N4010A-01

S E R V I C E N O T E

N4010A Wireless Connectivity Test Set

Customers may find the fan noise produced by the N4010A unacceptable

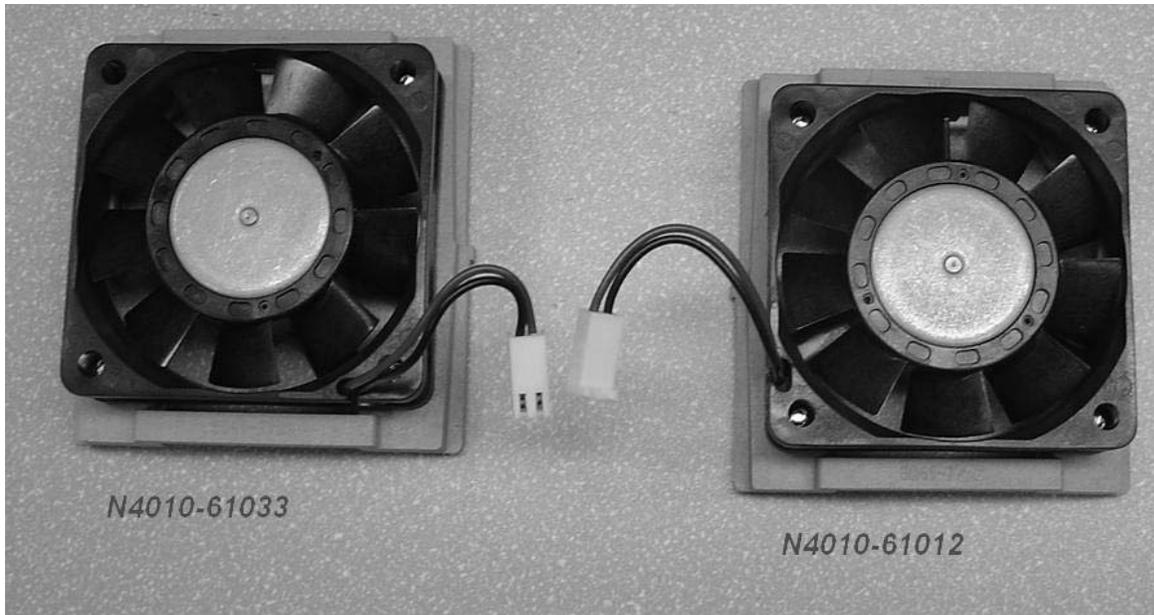
The instrument fan is now accessible. Remove the fan and the three filler plates by pulling them upwards away from the main deck.

The instrument fan is replaced by N4010-61012. A second fan, N4010-61033, is added where the filler plates were removed. The two fans are shown below

The new fans shown fitted in the main deck. Connect N4010-61012 to connector J9 and N4010-61033 to connector J10.
